REGULAR OPEN MEETING OF THE UNITED LAGUNA WOODS MUTUAL ARCHITECTURAL CONTROL AND STANDARDS COMMITTEE*

**Thursday, June 20, 2024 – 9:30 a.m.
Laguna Woods Village Board Room /Virtual Meeting
24351 El Toro Road, Laguna Woods, CA 92637**

NOTICE and AGENDA

BUILDING LOCATION PLAN
TRACT 5899—LOT NO. 3 W/2
BUILDING LOCATION PLAN
SHEET 11

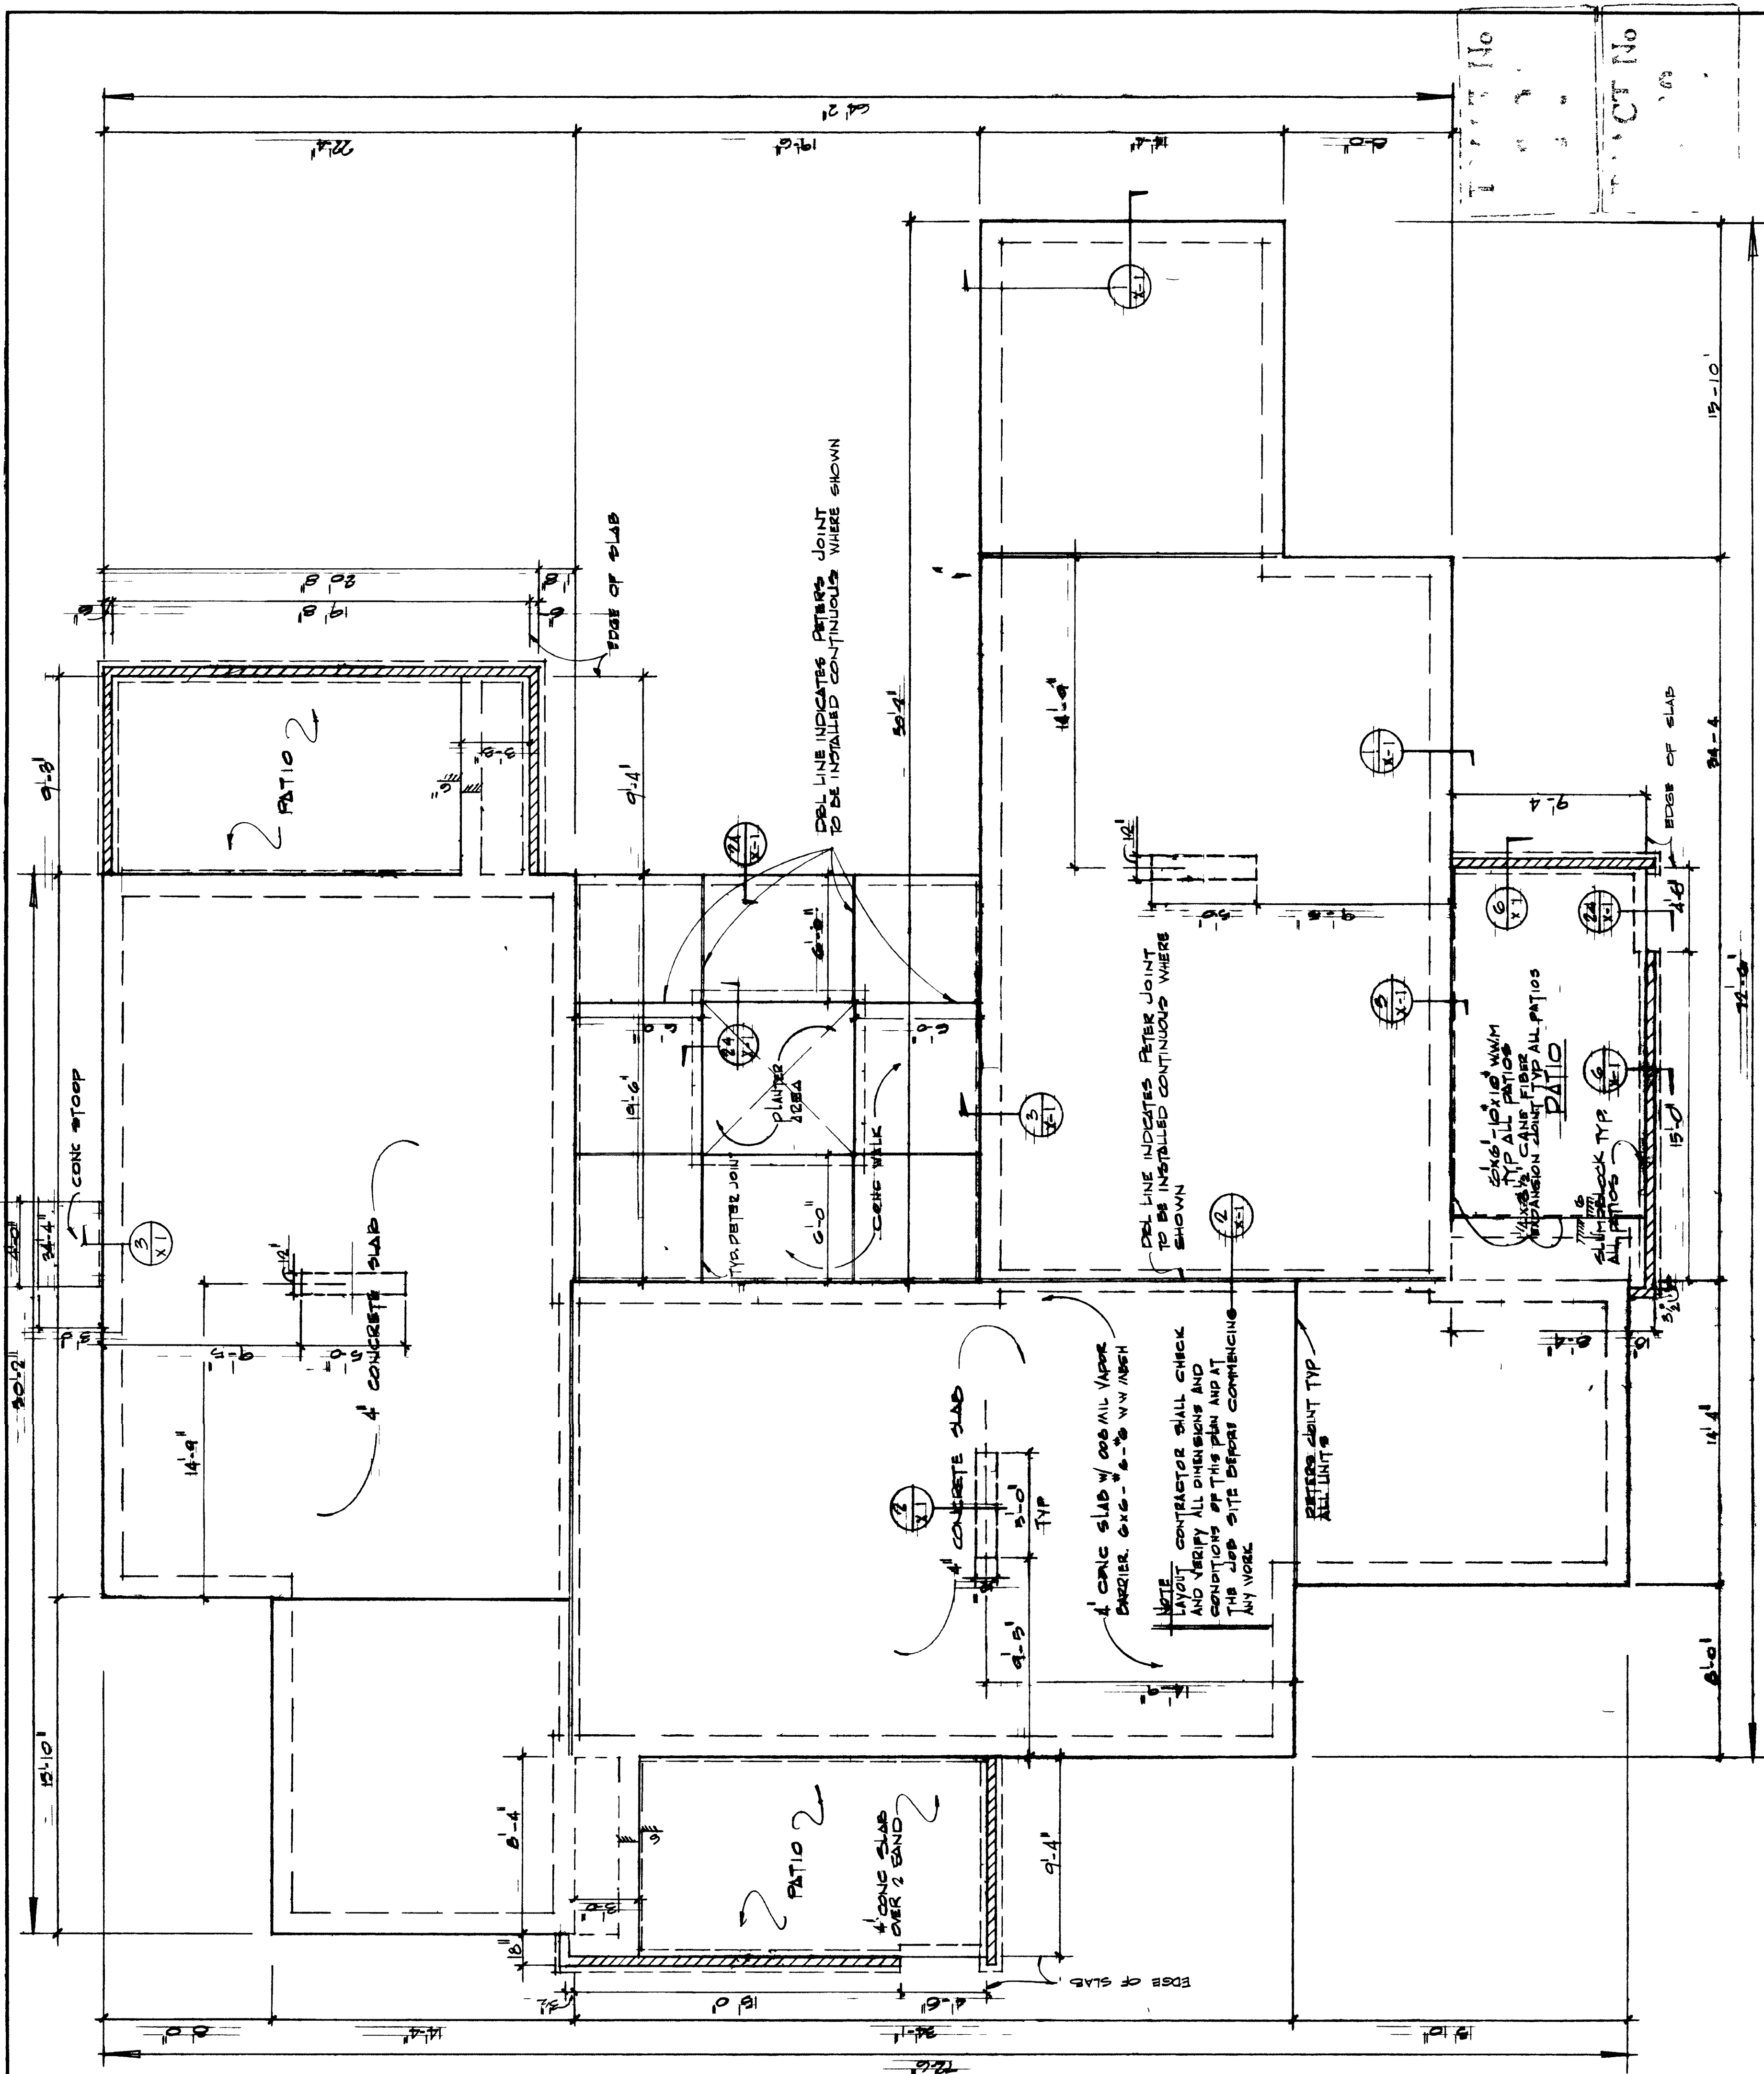
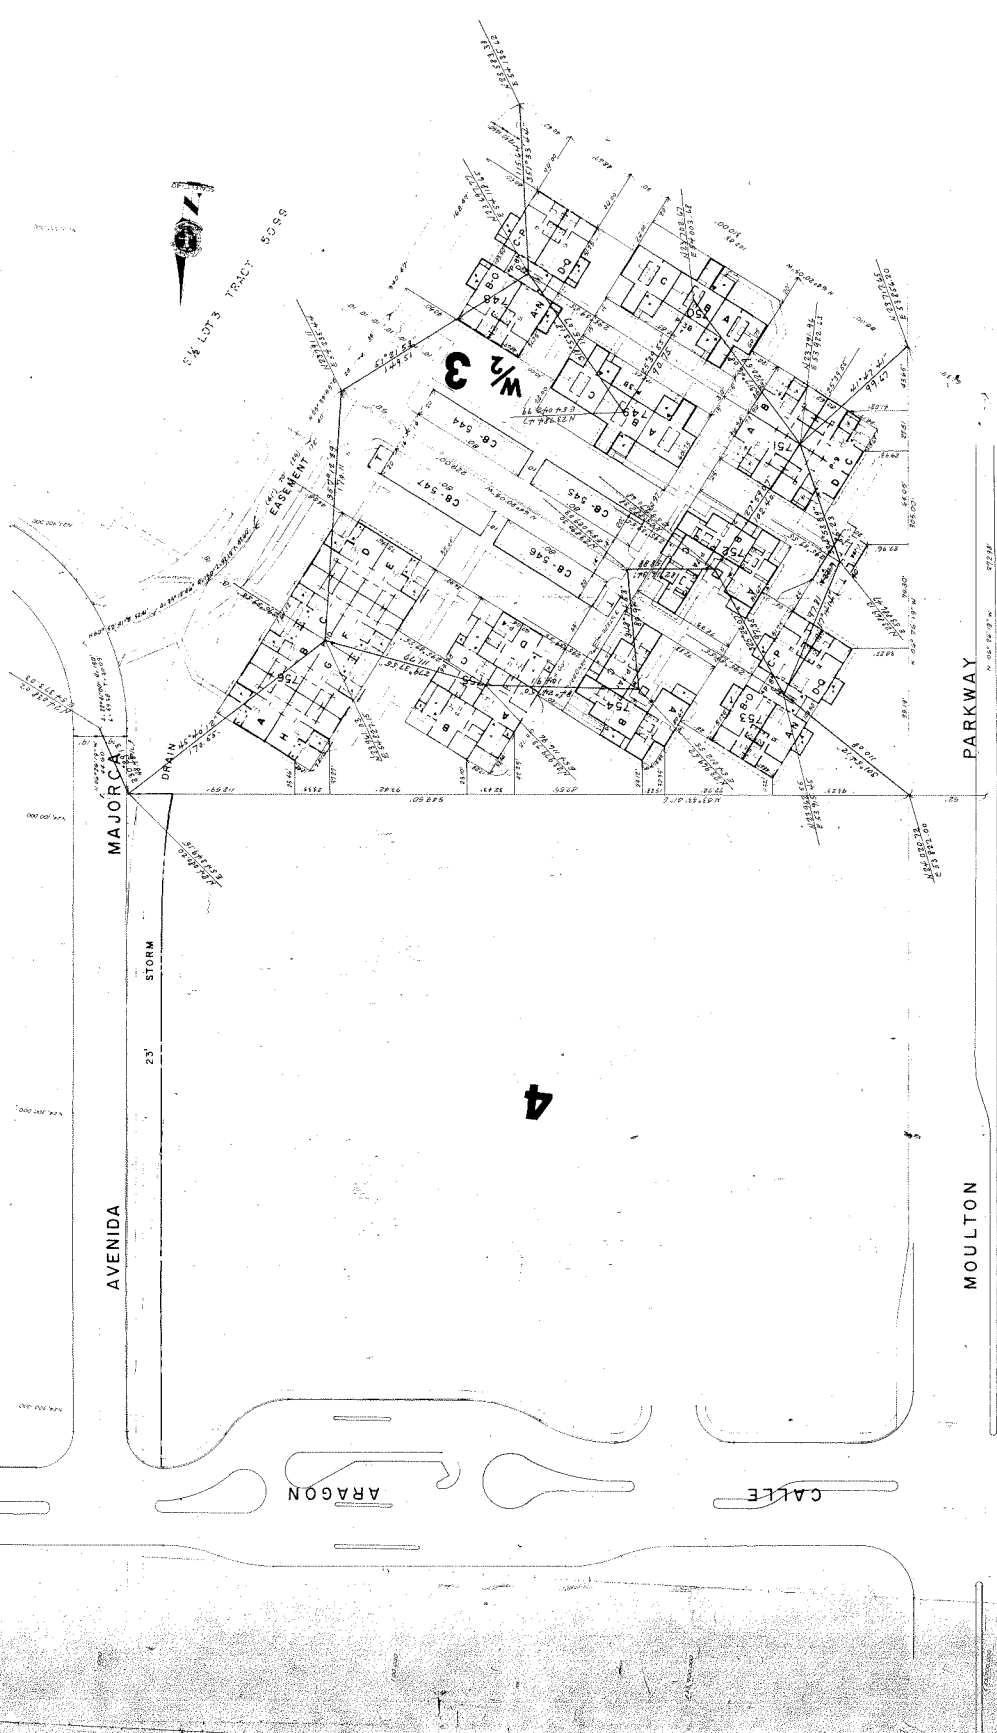
DATE: June 20, 2024
FOR: Architectural Control and Standards Committee
SUBJECT: 754-C: Request to Remove the Non-Exclusive Common Area Planter and Modify the Appearance of the Common Area Courtyard by Turning it Into a Seating Area

The member at 754-C is spearheading a request to remove the existing raised brick planter and replace with concrete level with the existing patio area. The members at 754-A and 754-B – who share this space – are in agreement. There is a precedent established as this was done at an adjoining courtyard at the opposite end of the patio area. However, there is no record as to who did the work and how it was paid. The planter area is currently designated as Common Area. The members would like the mutual to pay for the work; however, they are willing to pay if that becomes the requirement of the mutual.

Staff recommends that the United Architectural Control and Standards Committee (ACSC) approve the members request to remove the raised planter and replace with a concrete slab on the condition that the member(s) are responsible for all the initial replacement costs and subsequent maintenance. If approved, staff requests direction on how the costs for this removal should be covered.

4.24.0 SAMPLE FLOOR PLAN (SEE ATTACHED)

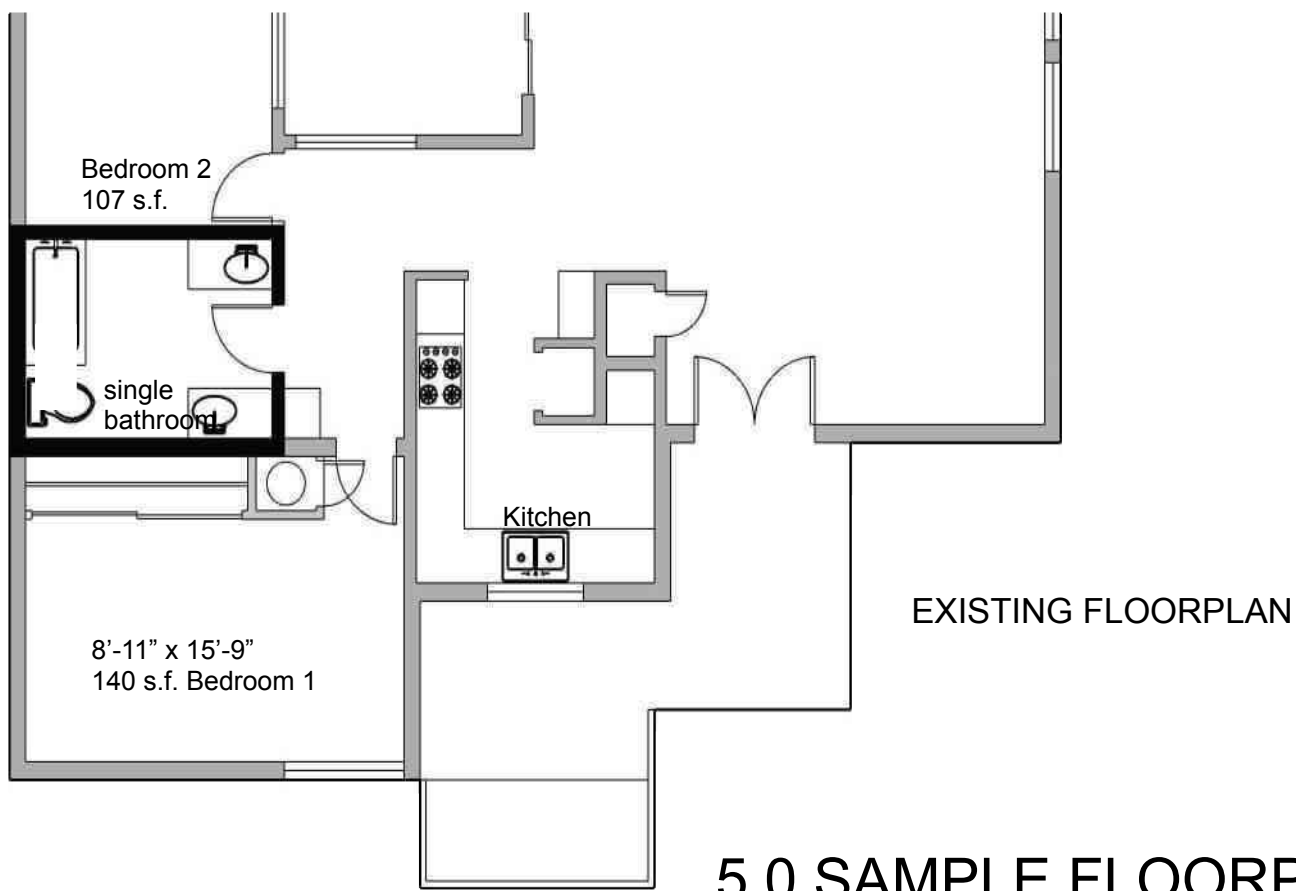
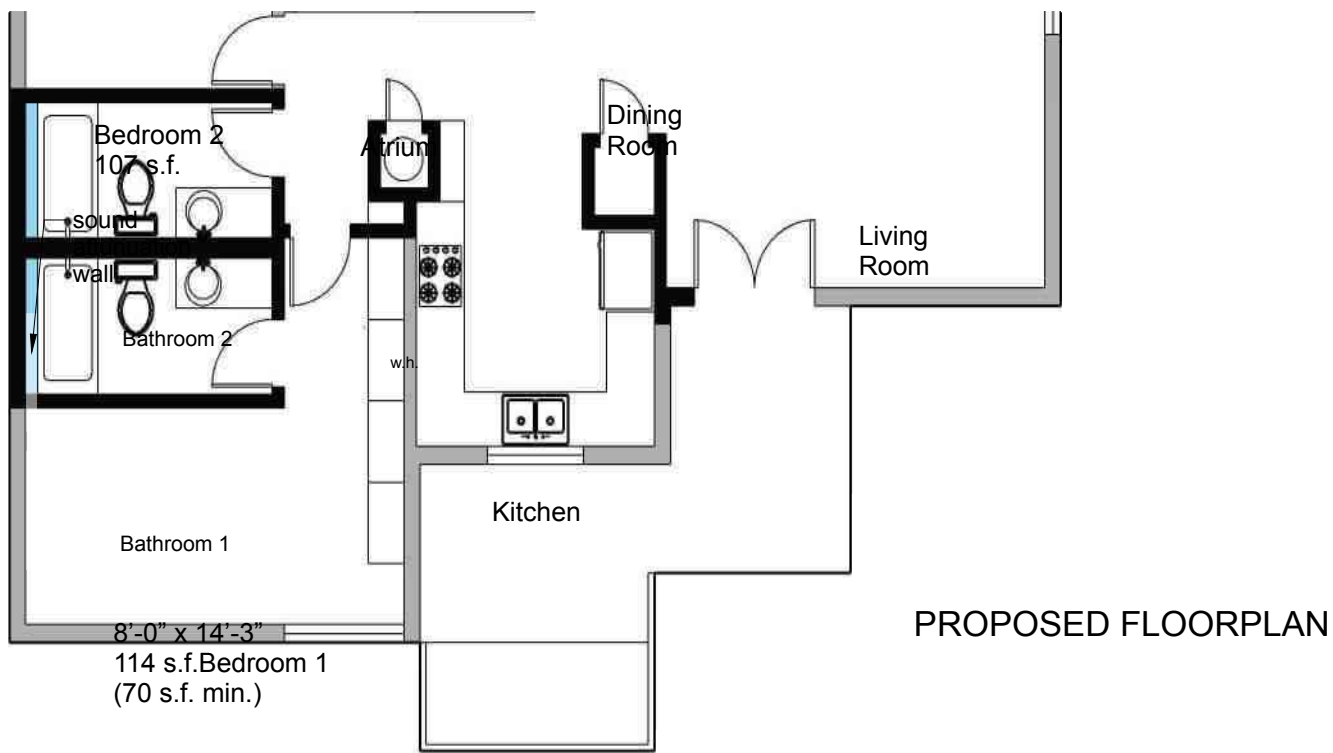
The suggested modifications to this standard are recommended in order to allow for: 1) Greater flexibility in the design process. 2.) Clarification of responsibilities and work flow process. 3.) Specifying compliance with all state and local building codes.
